## **Town of West Newbury**

**Request for Qualifications (RFQ)  
RFQ# 2023-WN-001**

# ***Dr. John C. Page Elementary School***

This Addendum #2 covers notes and questions from the briefing and tour, and additional questions received via email since then. Last day for questions is Friday May 12. Since the RFQ submittal deadline of May 19 is approaching, the goal going forward is to get responses back within 2 business days of questions.

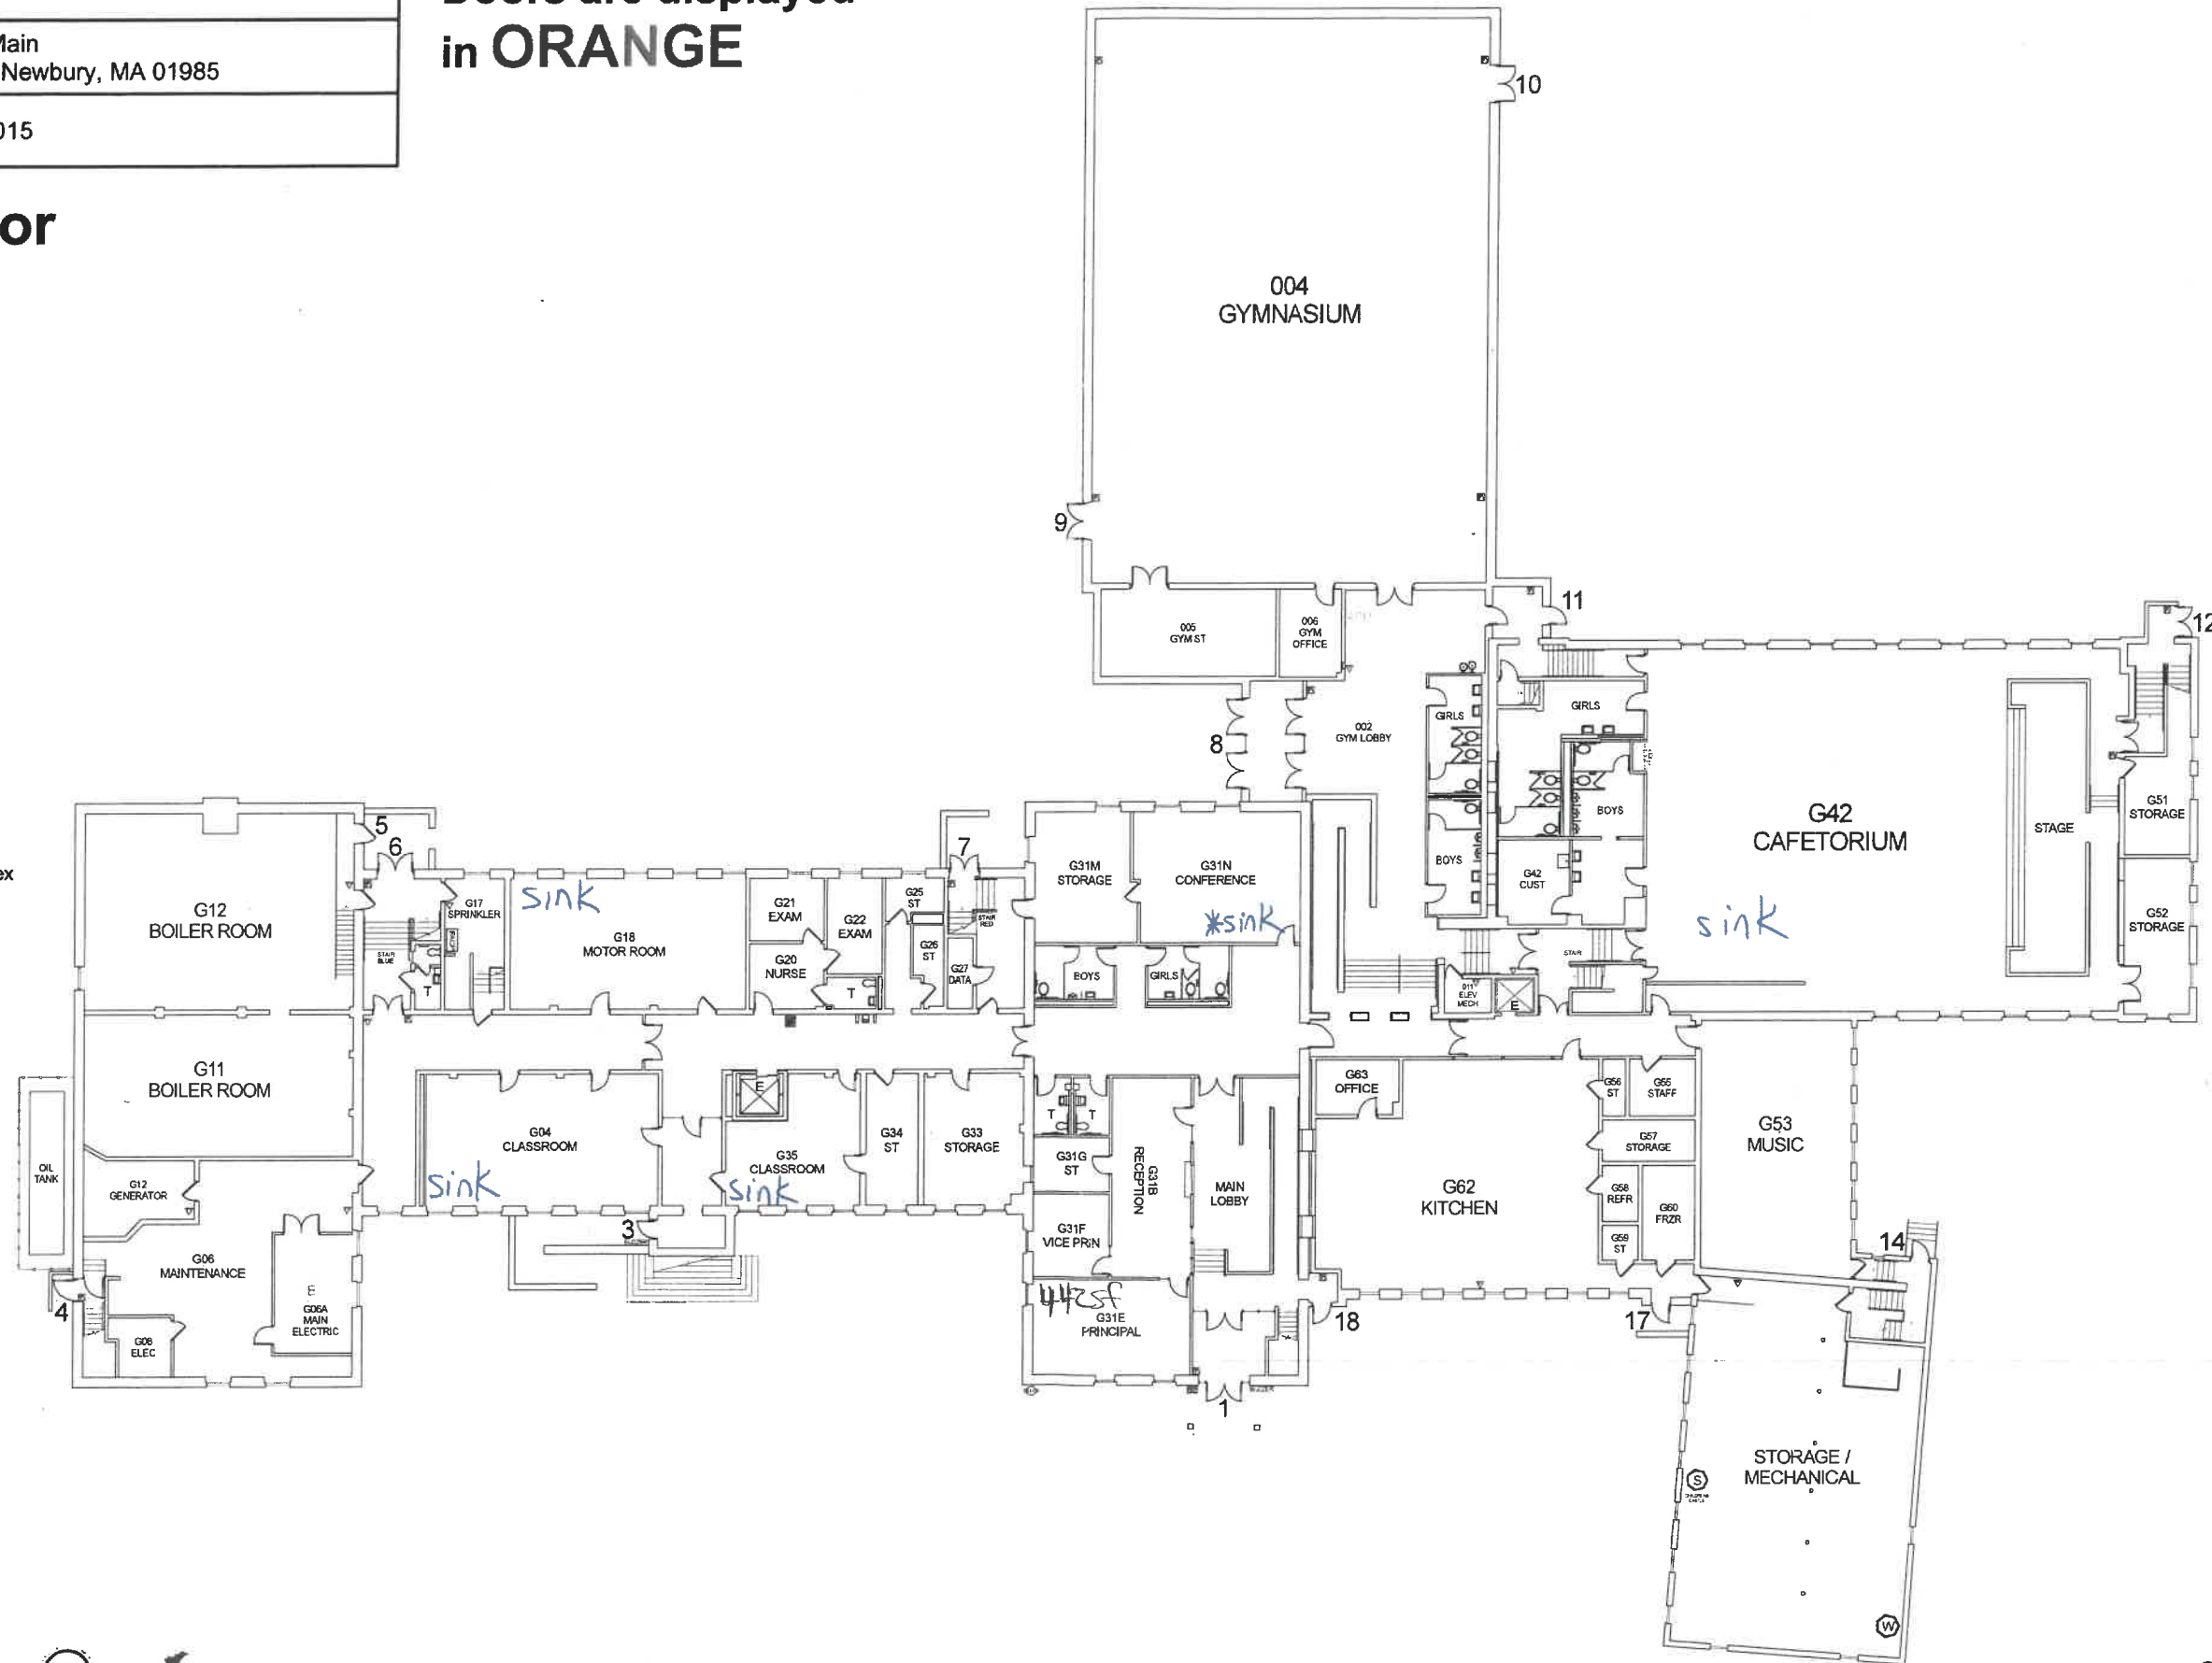
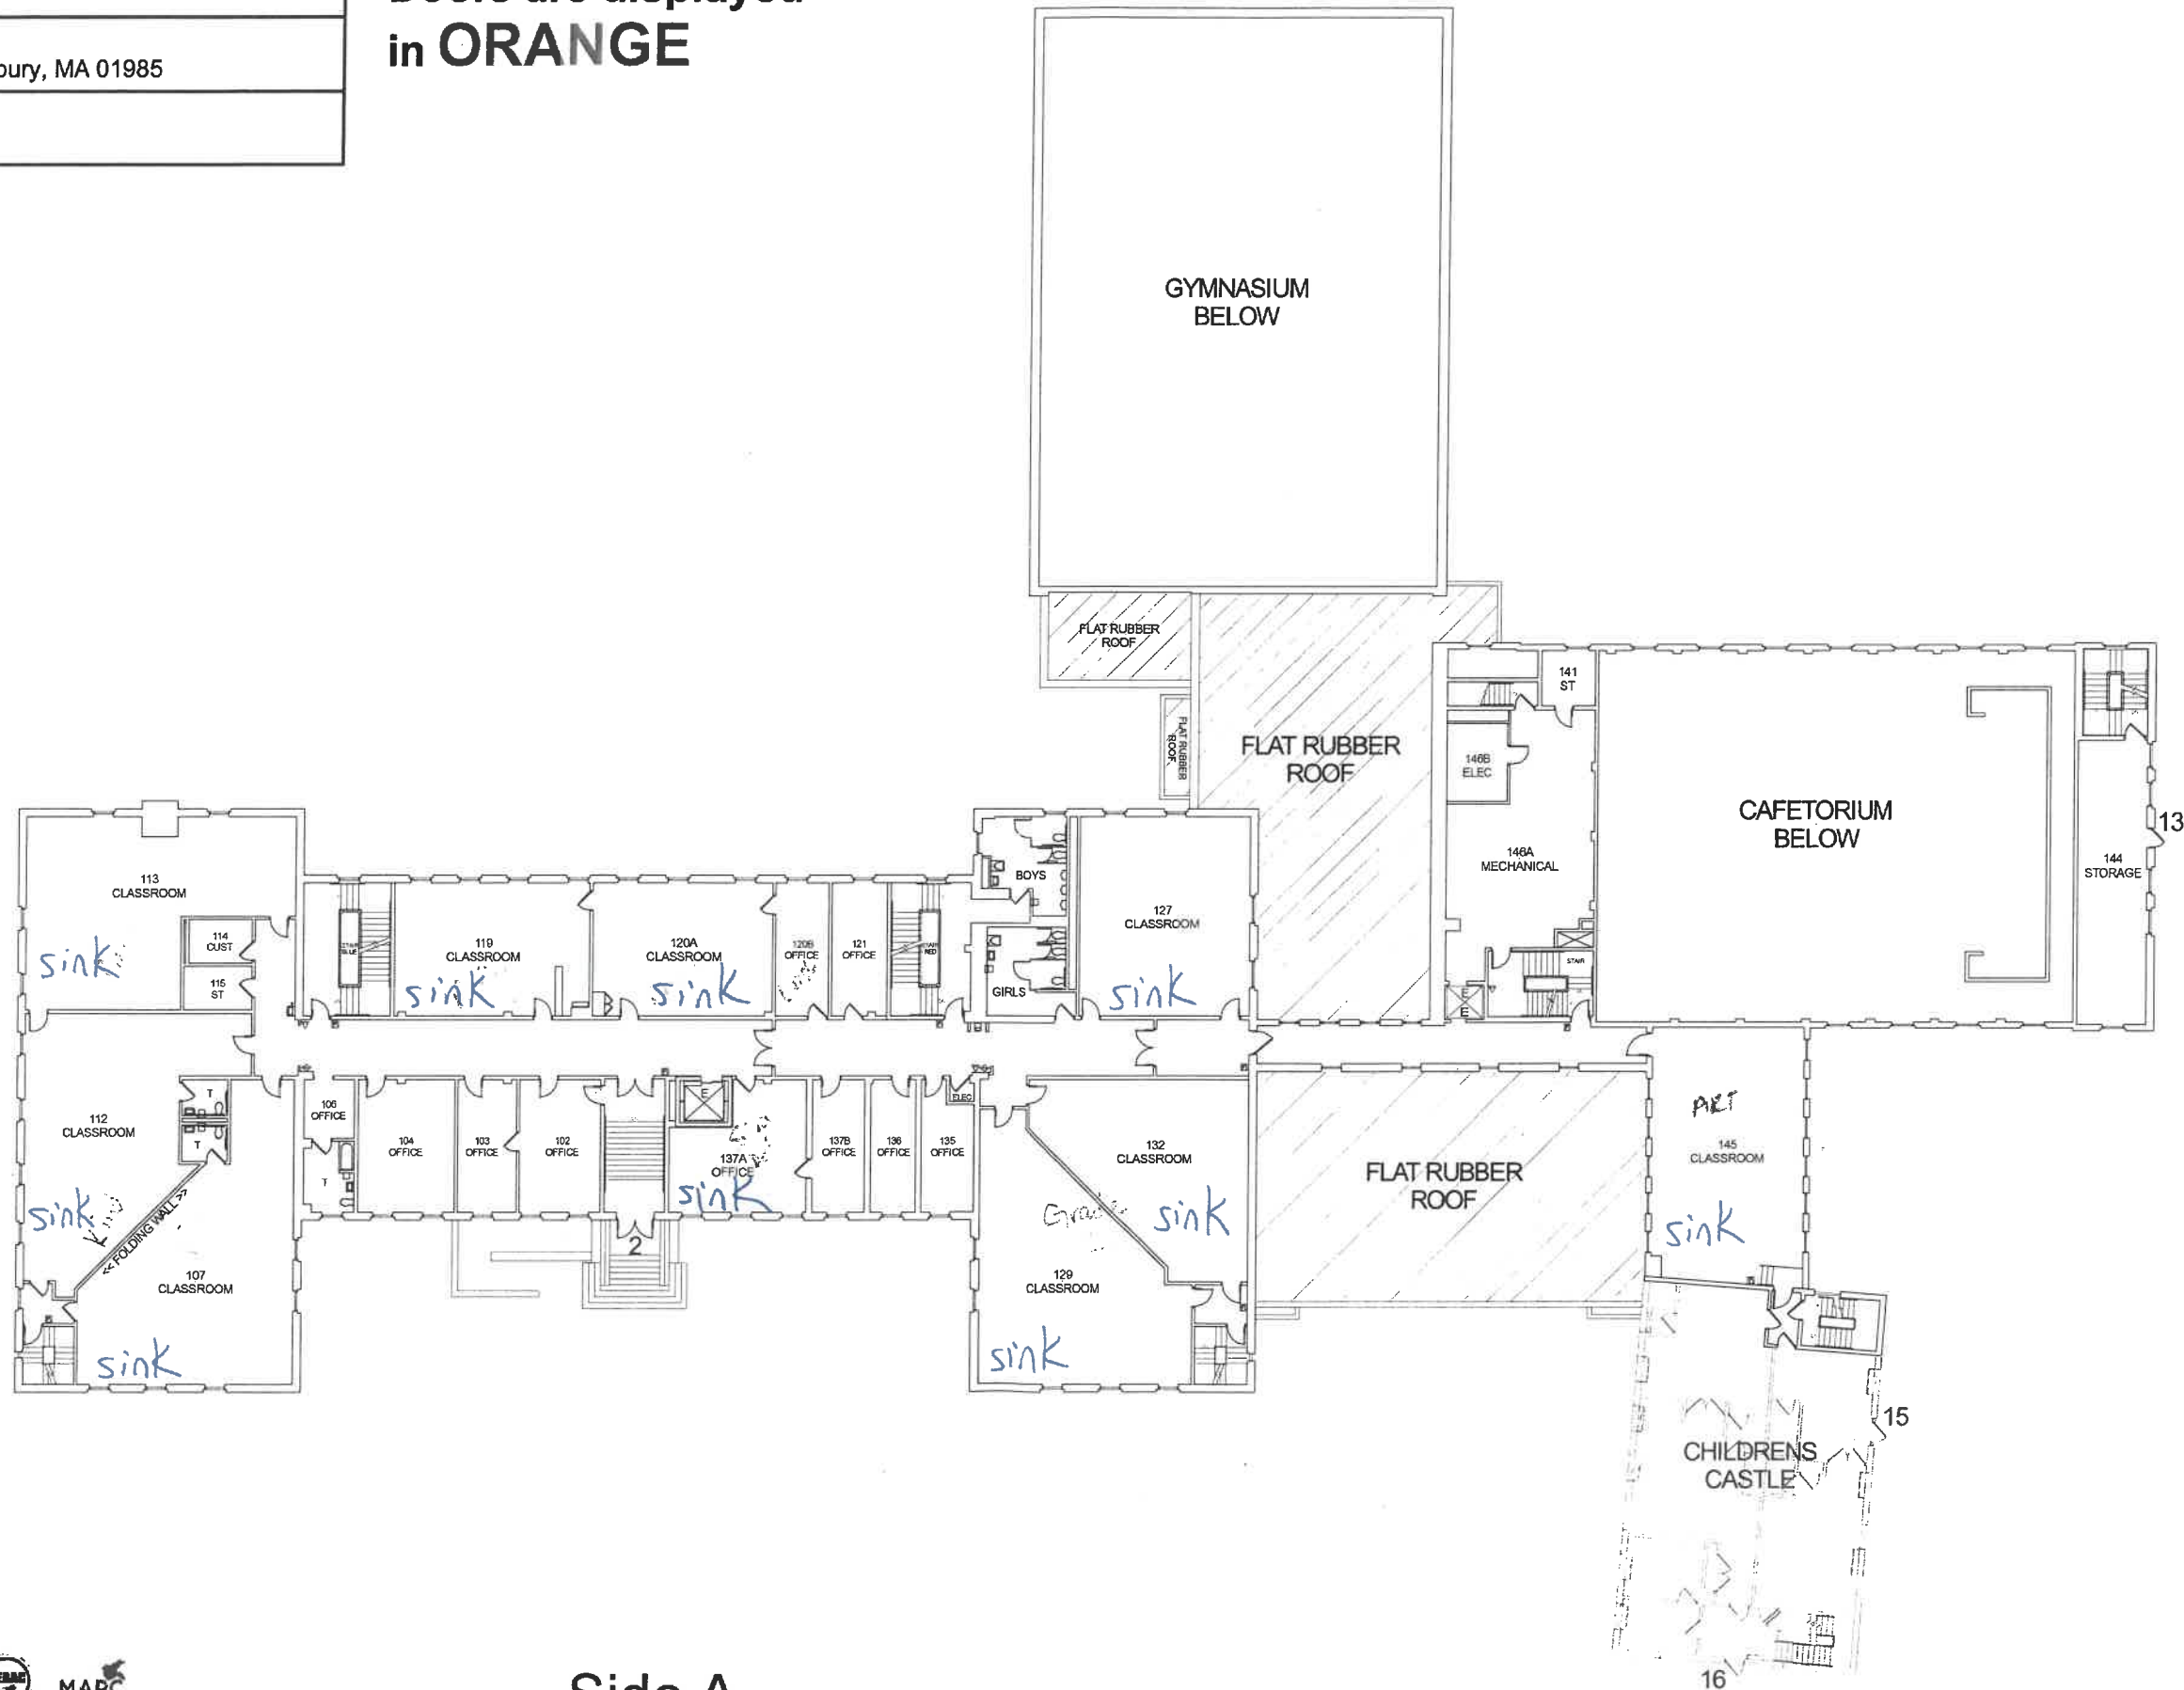
As photos were not available during the visit, can you share an egress plan of the building and/or any schematic plans as a reference?
